CITY AND BOROUGH OF JUNEAU
E7-6-011, DOWNTOWN SEAWALK - BRIDGE TO GOLD CREEK

MARK	DATE	DESCRIPTION	BY
1	9/16/15	ADDENDUM #2	EGW

ADDENDUM #2

LANDSCAPE MATERIALS  
PLAN - BRIDGE PARK

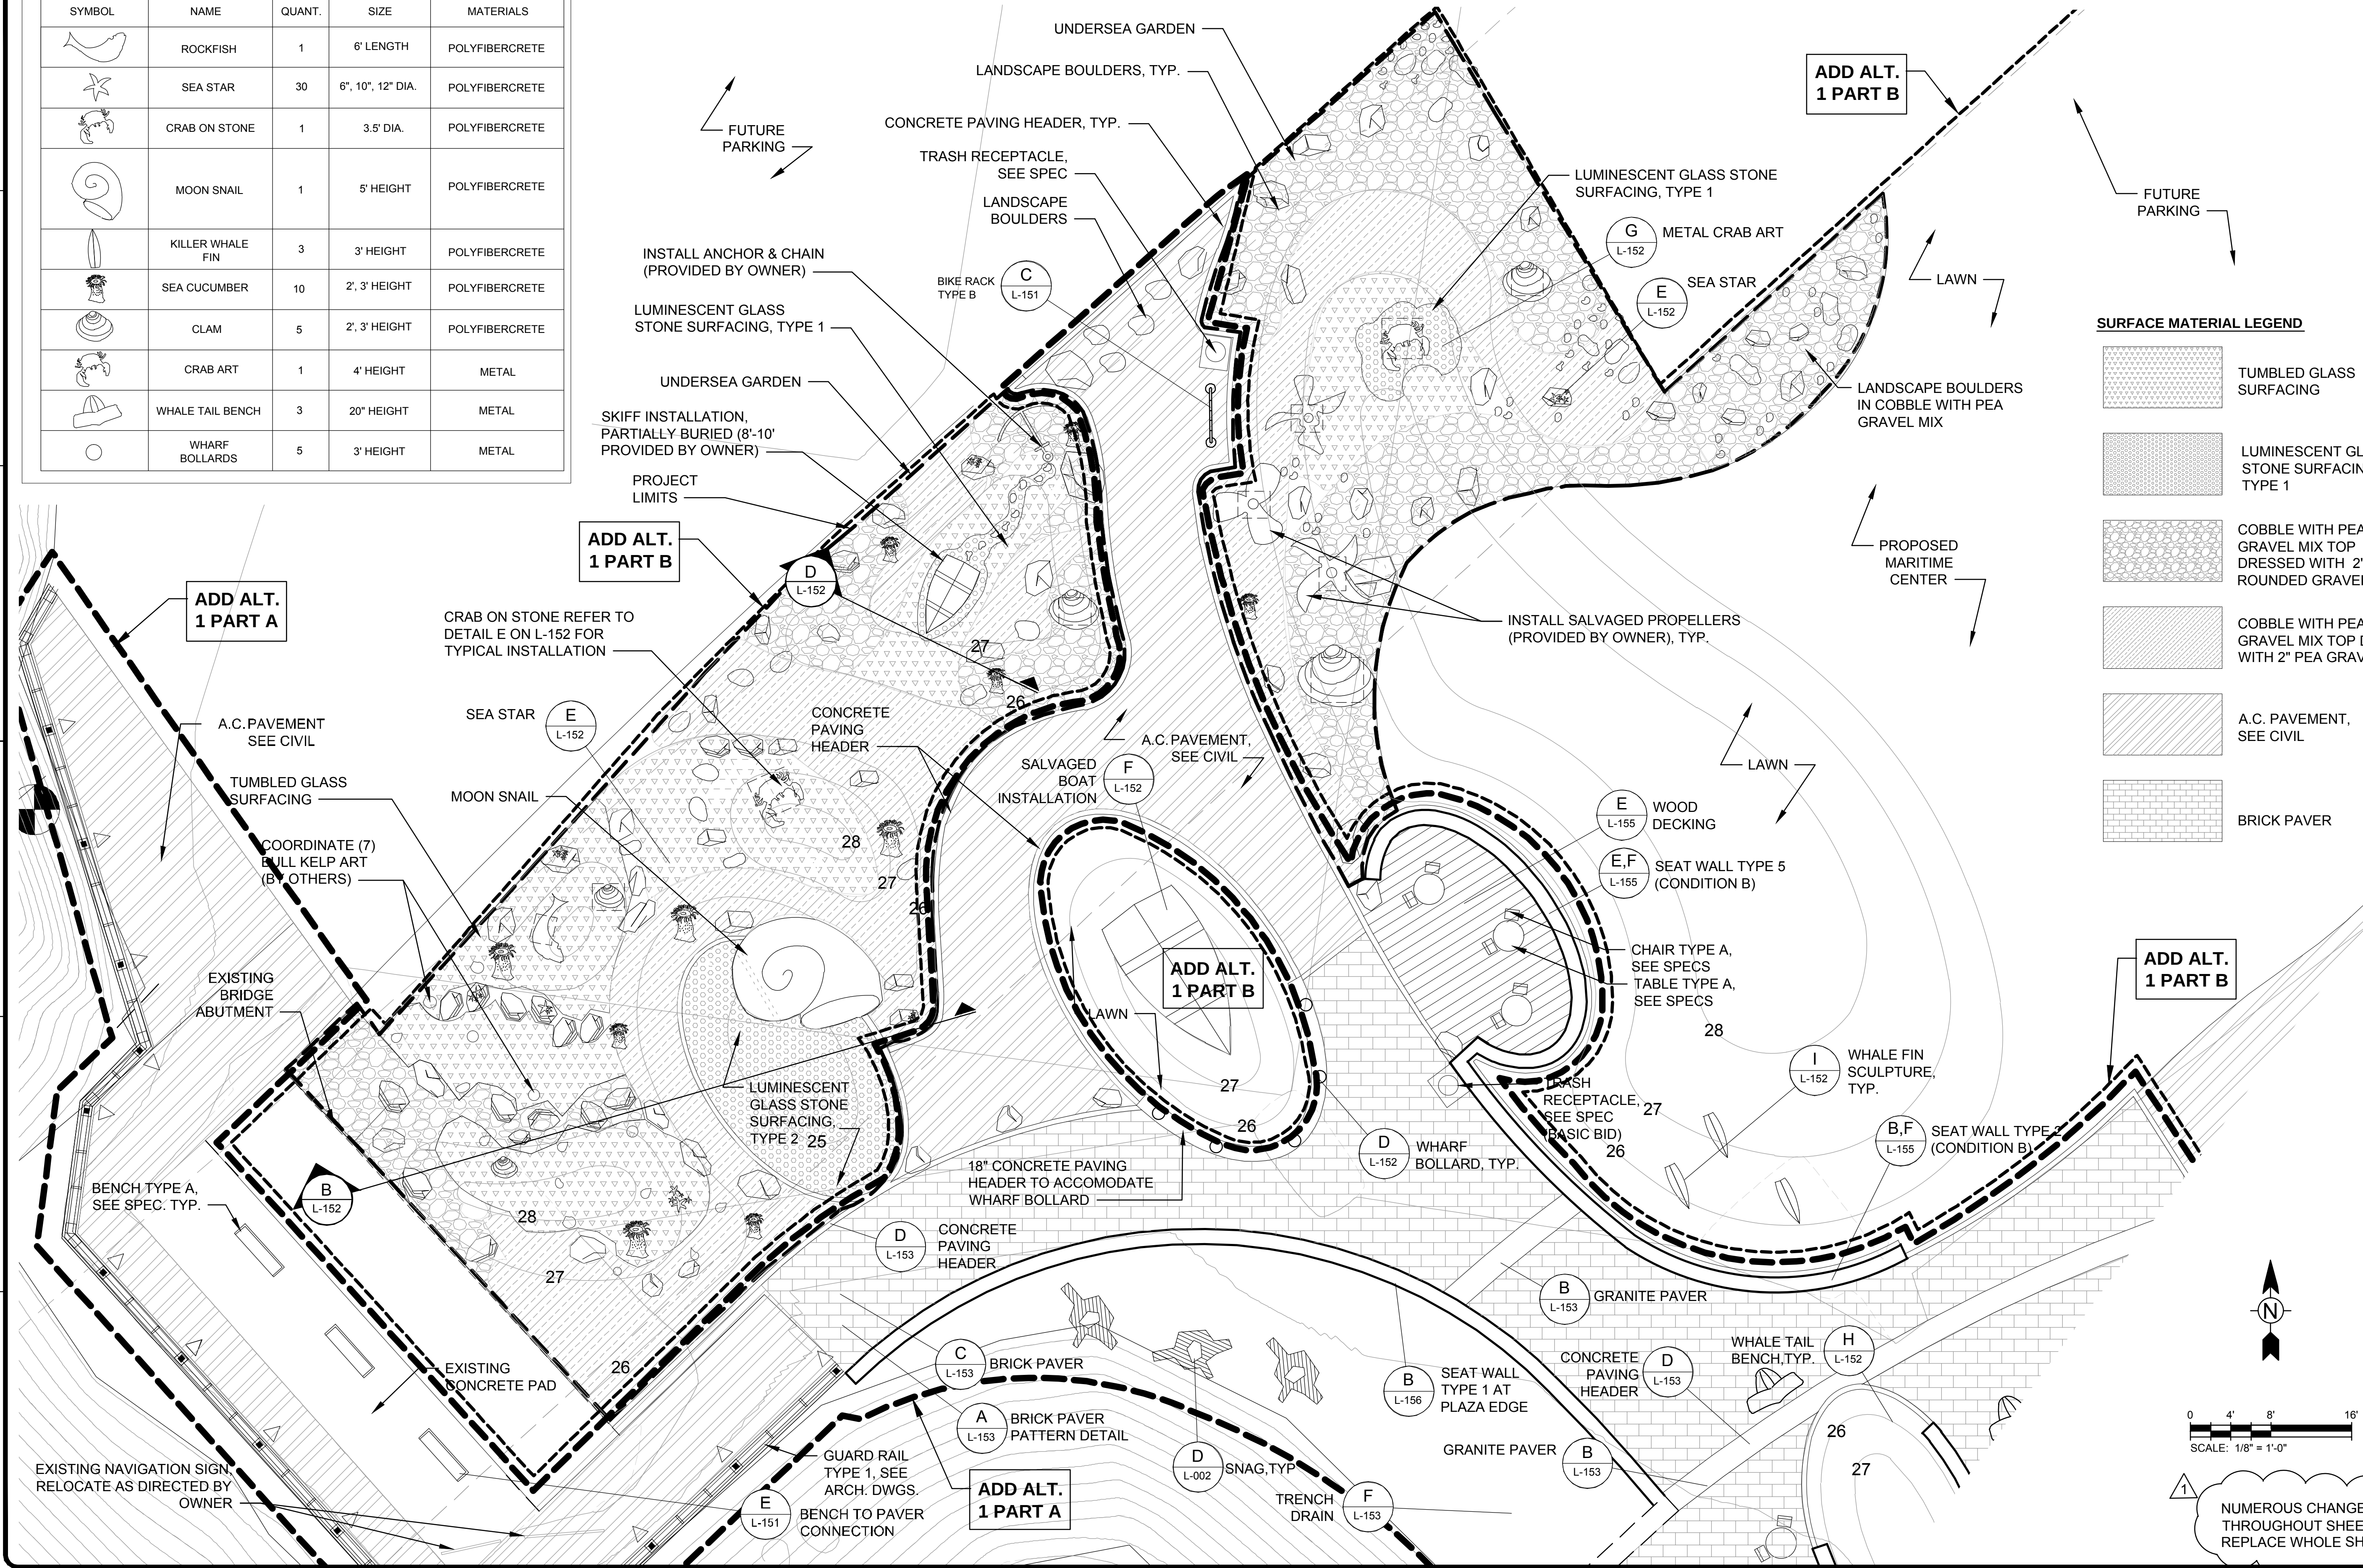
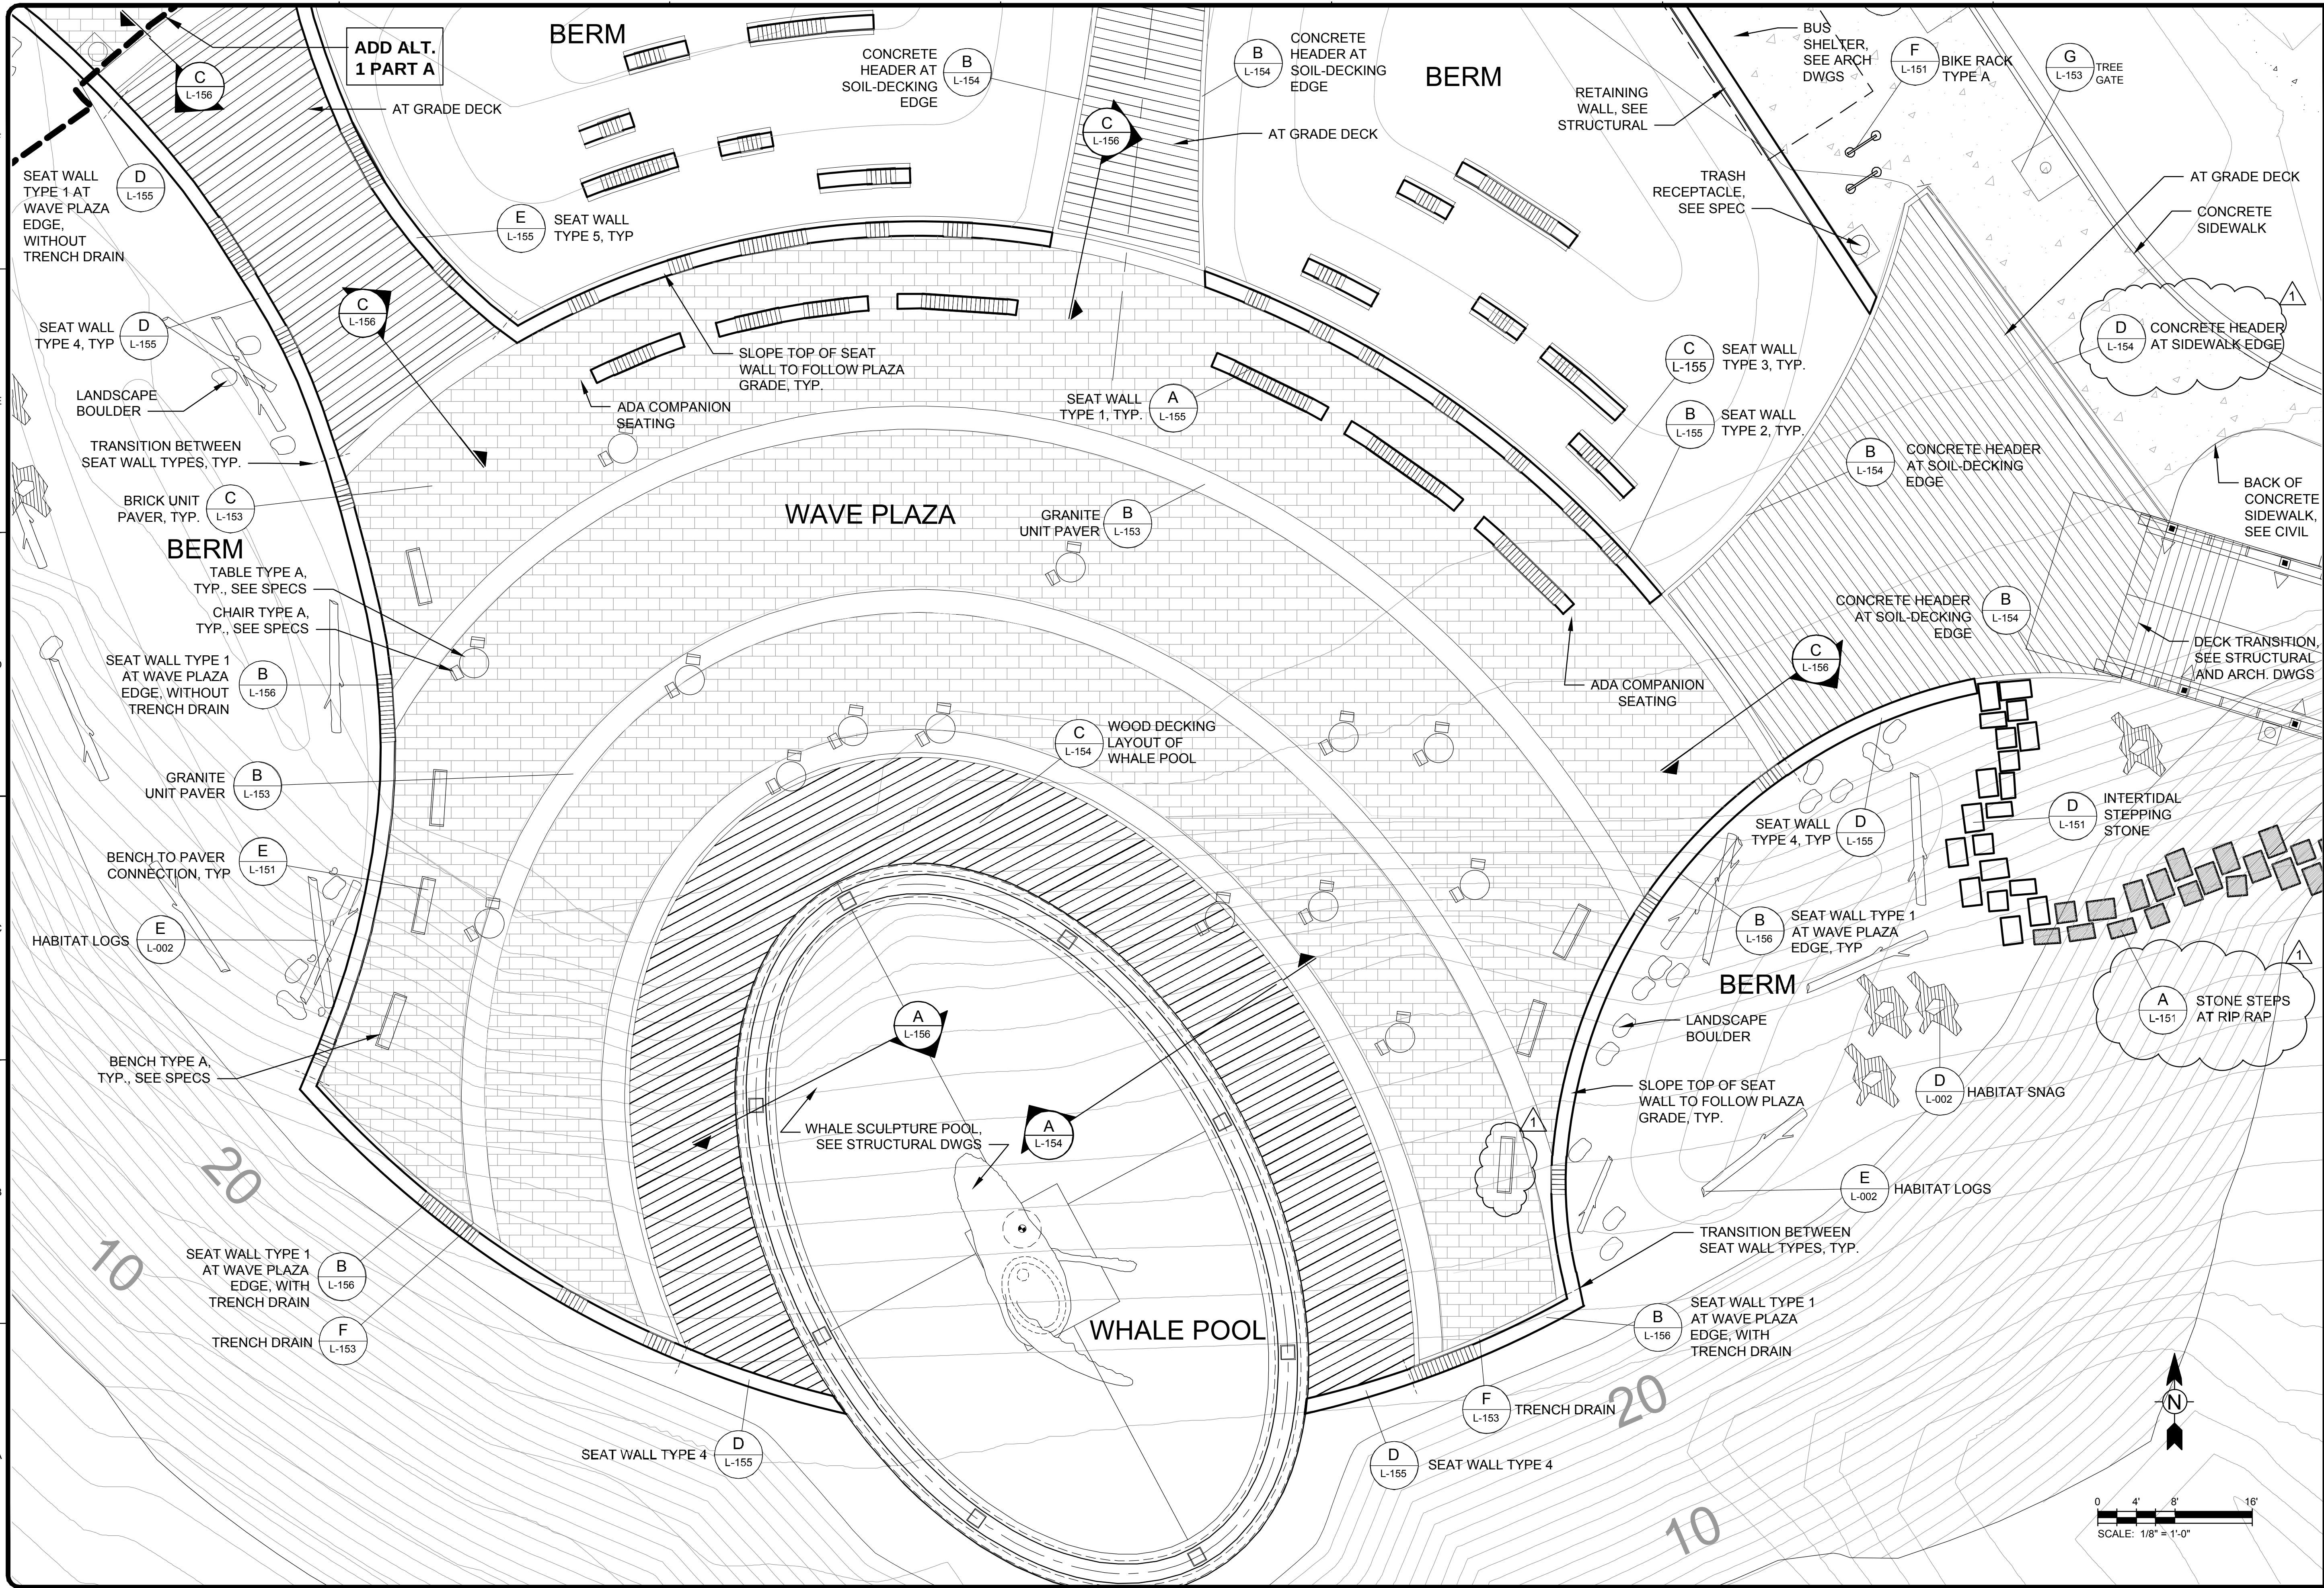
NUMEROUS CHANGES  
THROUGHOUT SHEET.  
REPLACE WHOLE SHEET.
